J A MCDONALD, INC.
VT/AOT BRIDGE - STEEL CULVERT REPLACEMENT
BRIDGE #6, VT ROUTE 58, IRASBURG, VT

D — 20' SPAN x 8' RISE BOX CULVERT LAYOUT — REV 1
Drawing No. C22283-L01A
Quantity: 1 | Project No: STPCULV30 | SHEET 1A OF 2A

D — 20' SPAN X 8' RISE BOX CULVERT LAYOUT — REV 1
Drawing No. C22283–L01B
Quantity: 1 — Project No: STPCULV30 — SHEET 2A OF 2A

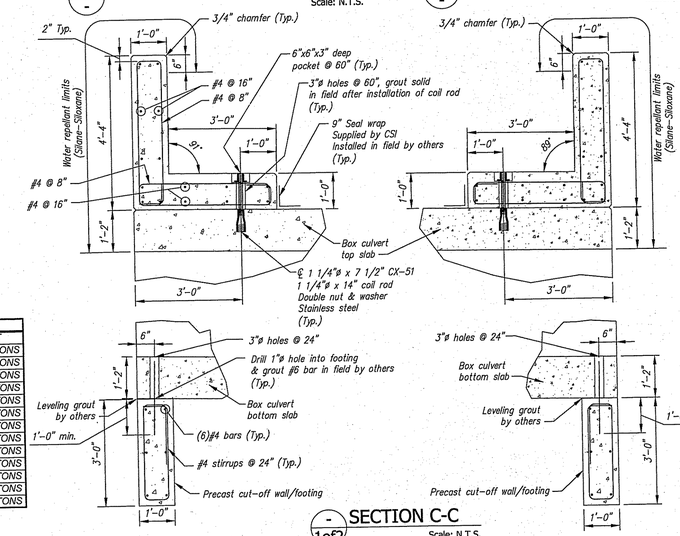
Rev.	Date	DESCRIPTION	By
5			
4			
3			
2			
1	01APR2015	CONSPAN WW ANCHORS WERE TYPE 'D', WWs WERE 10" THK, WW & FTG WEIGHTS UPDATED	RY

PRECAST ANCHOR
TYPE F ⚠1

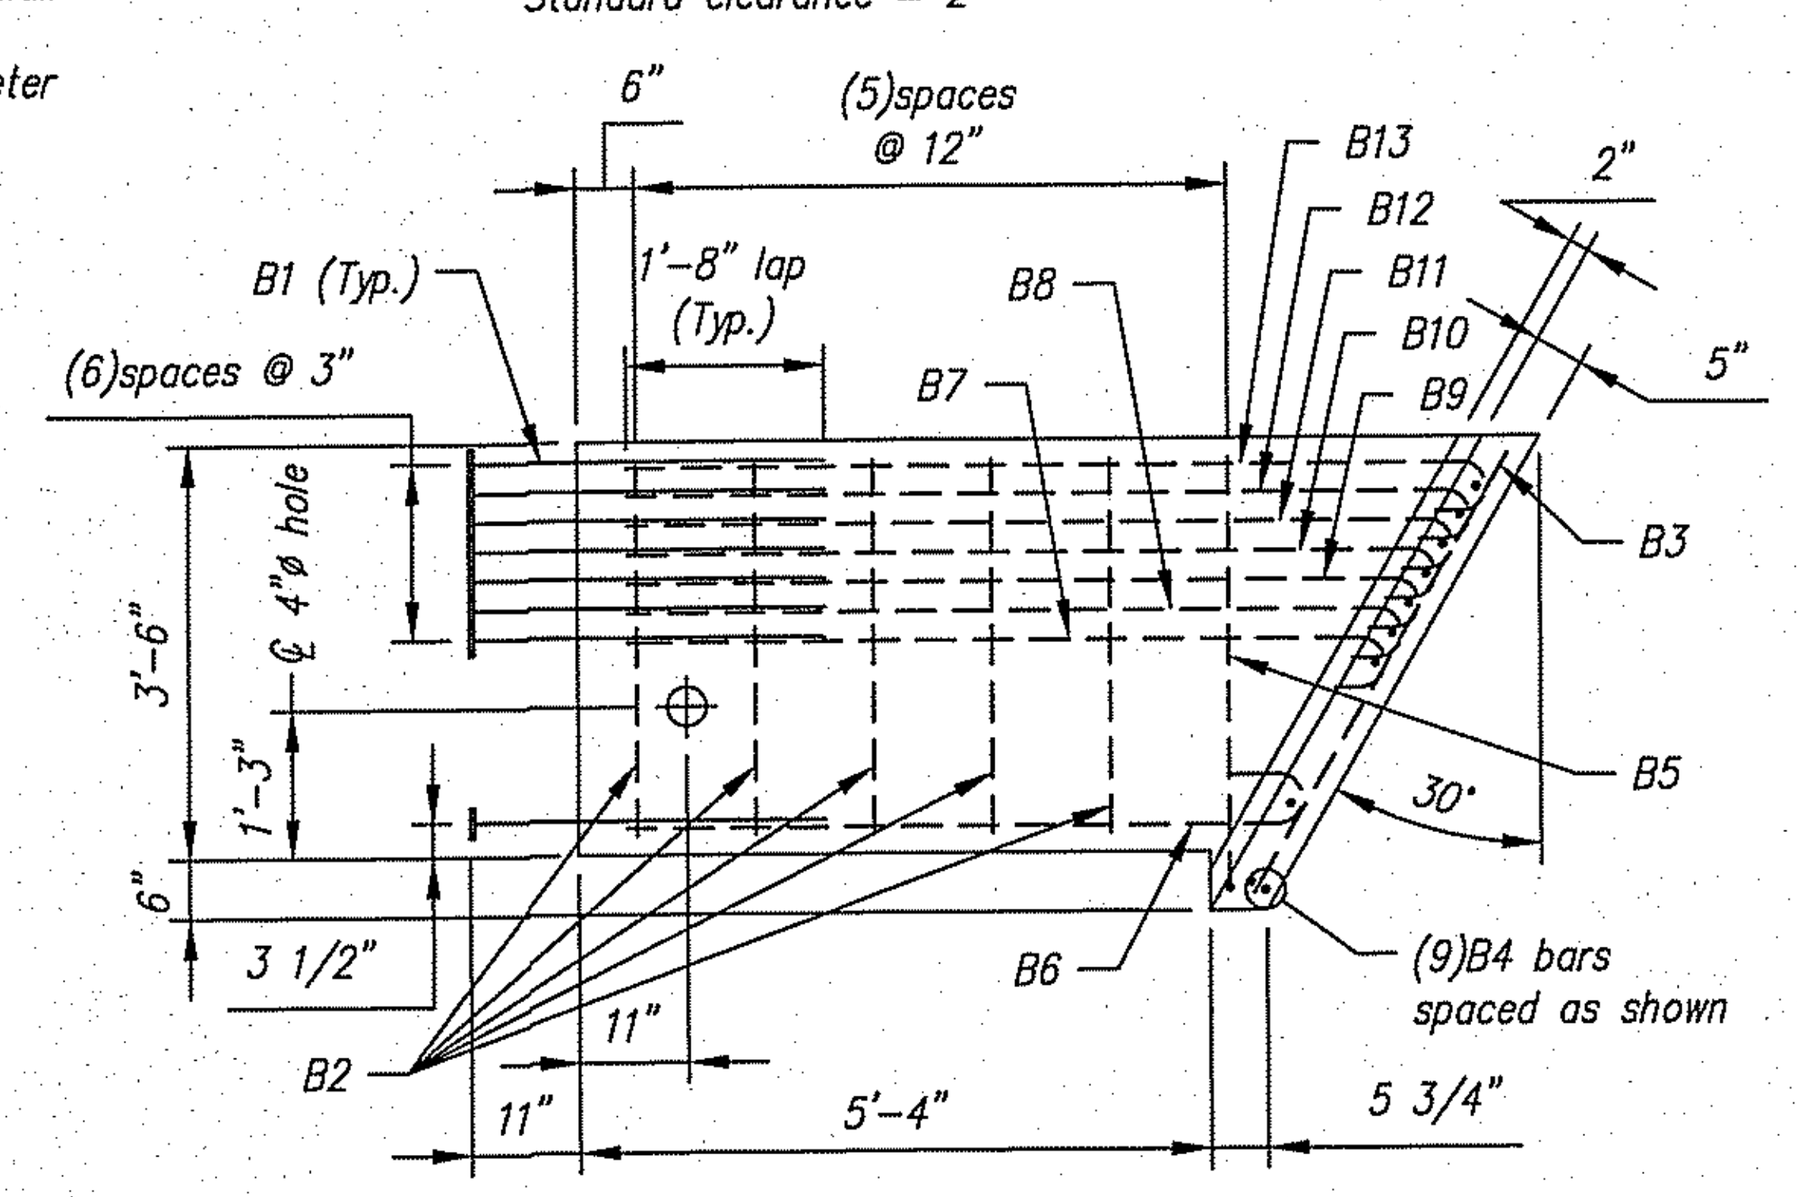
Rev.	Date	DESCRIPTION	By
5			
4			
3			
2			
1	01APR2015	CONSPAN WW ANCHORS WERE TYPE 'D', WWs WERE 10" THK, WW & FTG WEIGHTS UPDATED	RY
REVISIONS
